Office Action Summary

09/531,135

WATANABE, TOHRU

Hogan & Hartson Docket No. 81784.0027
 Serial No. 09/531,135
 Applicants: WATANABE, et al.
 SOLID STATE IMAGE PICKUP
 APPARATUS
 Replacement Sheet

Fig. 3

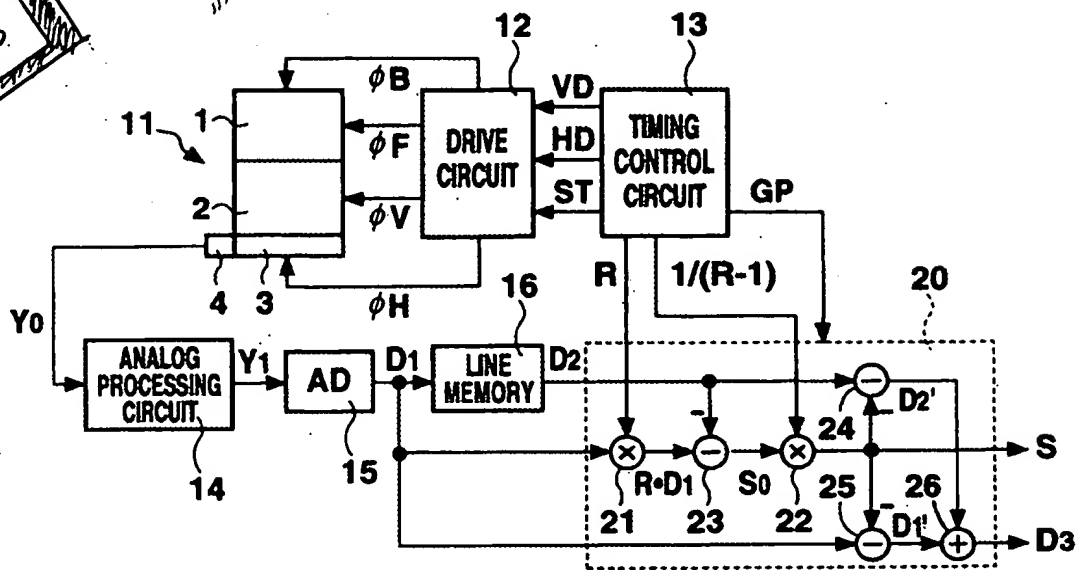
1. Applicant's arguments filed July 14, 2005 have been fully considered but they are not persuasive. However, Applicant's amendment to Figure 3 overcomes the previous objection; there are no further objections.
